Kensington Heights Site Plan No. 820140040

Staff Report Date: 04/17/14

Description

Figure 4: Areas of Community Concerns

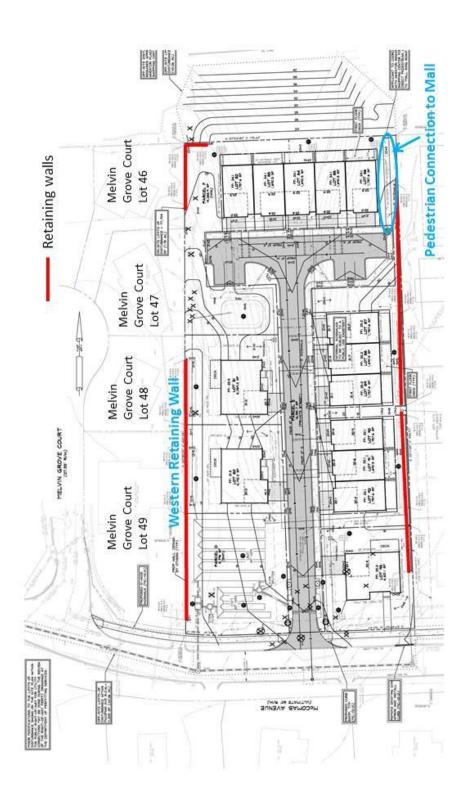
In response, the Applicant reduced the height of the proposed retaining wall to be no more than four feet at its highest point (Figure 4). In compliance with County code requirements, parts of the wall will be topped with a fence/railing no more than approximately three feet tall. At its highest, the wall, including the fence/railing will be approximately seven feet. As a comparison, the average residential privacy fence is up to six feet. To make sure that the proposed retaining wall/fence does not become too tall and looming over the adjacent properties, Staff recommends that the fence/railing be transparent (e.g. metal railing). Staff finds that the height of the proposed retaining wall with a transparent fence/railing is reasonable. The retaining wall is needed due to the topography of the site and to contain and manage all stormwater runoff on-site, which will rectify the existing condition of stormwater runoff flowing to the neighboring properties.

Mr. Agliata fears that whenever Westfield Wheaton Mall redevelops, it will be required to complete the pedestrian connection on the Mall property (Figure 4). He disagrees with having a pedestrian connection to the Mall in this location because of the area's steep topography and the safety and subsequent liability concerns with creating this connection. He argues that the Sector Plan did not envision a pedestrian path in this location. Westfield also sent a letter in opposition to this recommendation which is attached as Attachment F at the end of this report. The letter further points out that the fifth general note on the Schematic Development Plan for the project states:

The existing informal path on the Subject Site shows that there is a demand for a pedestrian connection to the Westfield Wheaton Mall property in this location. Although the Sector Plan does not specifically recommend a pedestrian connection on the Subject Site, it discusses the green buffer between the Mall's Ring Road and the adjoining residential community to the south (which includes the Subject Site). It states on page 53, "Also consider additional shared use path connections through the buffer to the neighboring community." Despite the note in the Schematic Development Plan, quoted above, the Planning Board included the recommendation for this connection in its approval of the Preliminary Plan for the Subject Site. Therefore, Staff recommends that the Applicant provide the proposed pedestrian connection as shown on the approved Preliminary Plan. In the future, the Planning Board can decide whether or not Westfield Wheaton Mall should provide this connection.

DPS-ROW CONDITIONS OF APPROVAL Attachment D

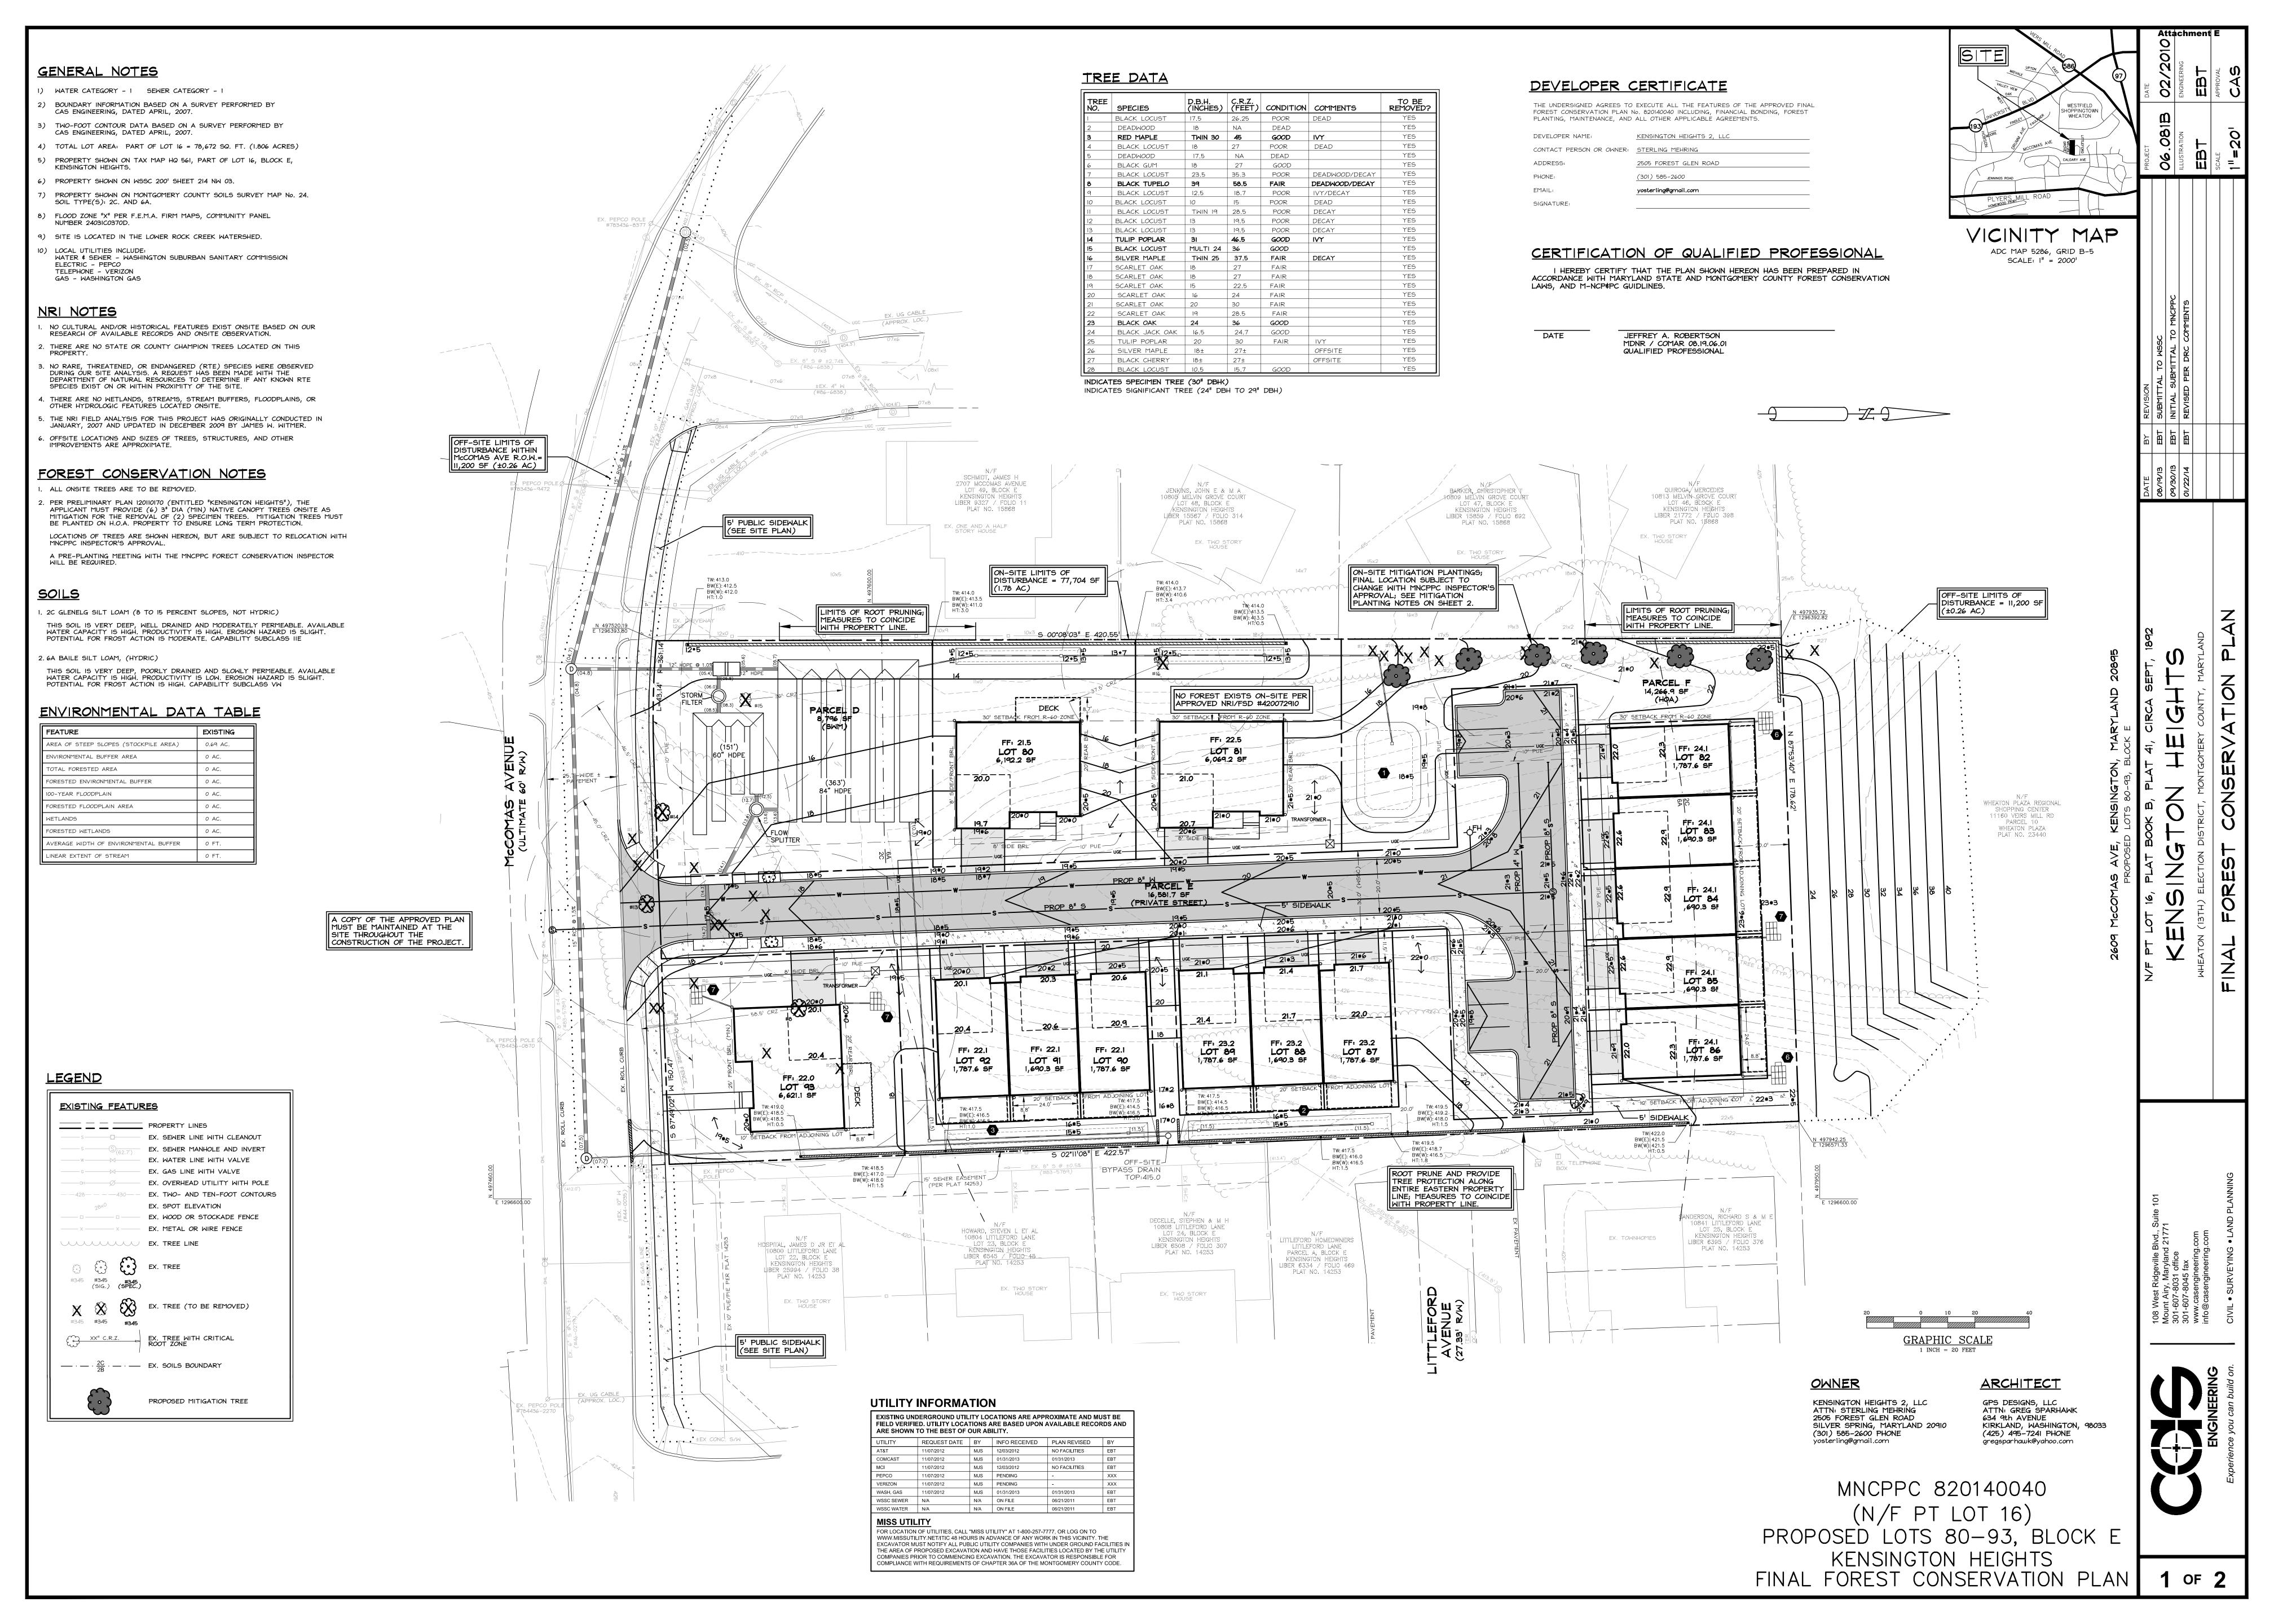
We approve site plan file "07-SITE-820140040-003.pdf V6" subject to the followings to be conditions of the certified site plan to be done prior to ROW permit stage:

- o Private open space covenant;
- Slope/drainage easement;
- o Investigate and re-route the proposed storm drain out of pavement;
- o Private streets to be built to tertiary roadway structural standards;
- o Handicap ramps on all plans should match the site plan file above.
